Commonwealth Edison

Subject: Braidwood Station Units 1 and 2
Response to Unresolved Issues Contained
In Draft SER-NUREG 1002
NRC Docket Nos. 50-456/457

Commonwealth Edison Company
Response to the Open Items Contained in the Braidwood
Draft SER-NUREG 1002 dated July 15, 1983

FIGURE 13.1-1

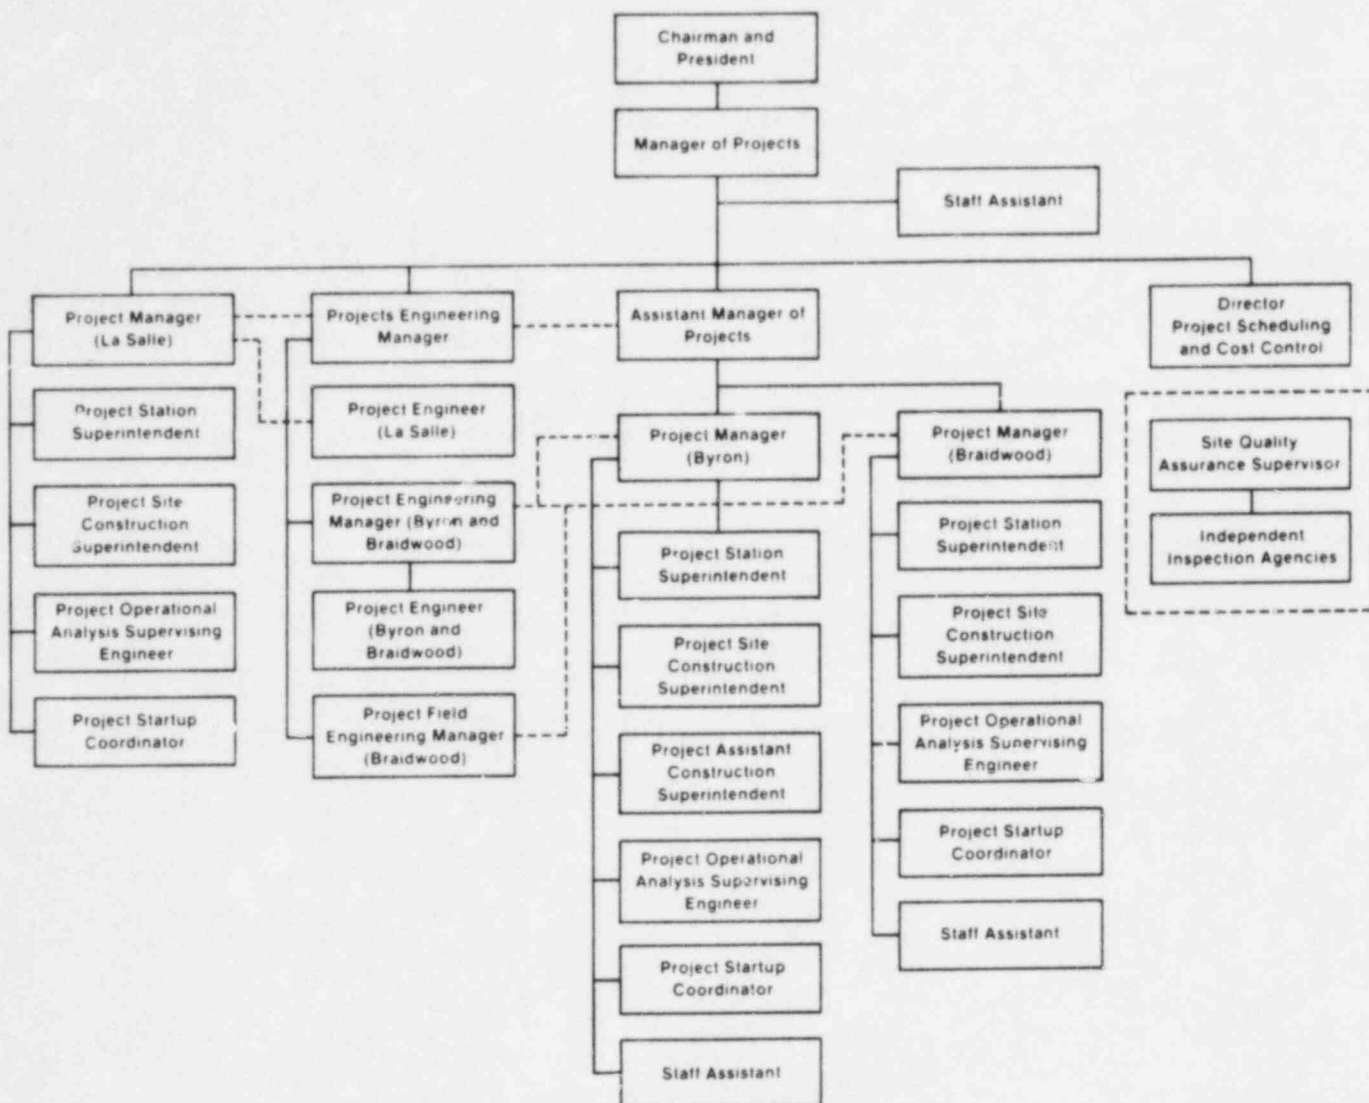
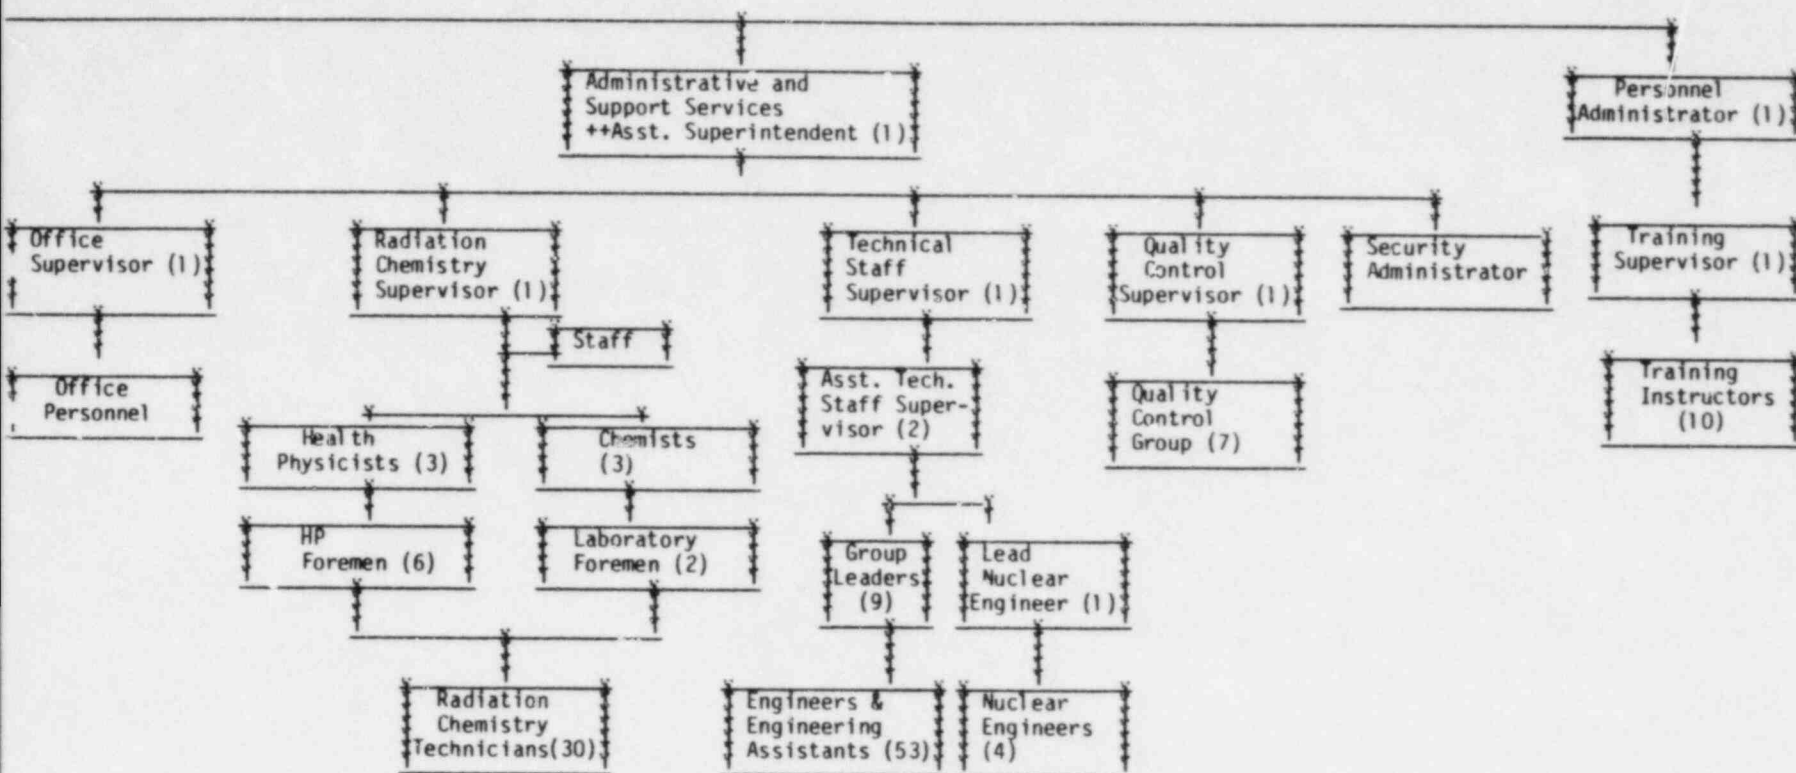
(5) Personnel on Shift with Previous Commerical PWR Experience During Startup Phase - Section 13.1.2.1*

Figure 13.1-1 has been revised to reflect the current Project Management Organization and has been provided in Amendment No. 43 to the FSAR. A copy of same is attached for convenient reference. The current revision of the Commonwealth Edison Company QA Topical Report CE-1A is Revision No. 25. The Braidwood Station organization is described on the attached Figure 13.1. Reporting directly to the Station Superintendent are the Maintenance Assistant Superintendent, the Operating Assistant Superintendent, the Administrative and Support Services Assistant Superintendent, and the Personnel Administrator. The Site Quality Assurance Group is independent (not shown on Figure 13.1) of the operating organization and reports directly to the Director of Quality Assurance (Operations) offsite as described in Topical Report CE-1A, Revision 25. The plant staff presently consists of about 246 individuals with a projected number of 500 individuals by the Unit 1 fuel load date.
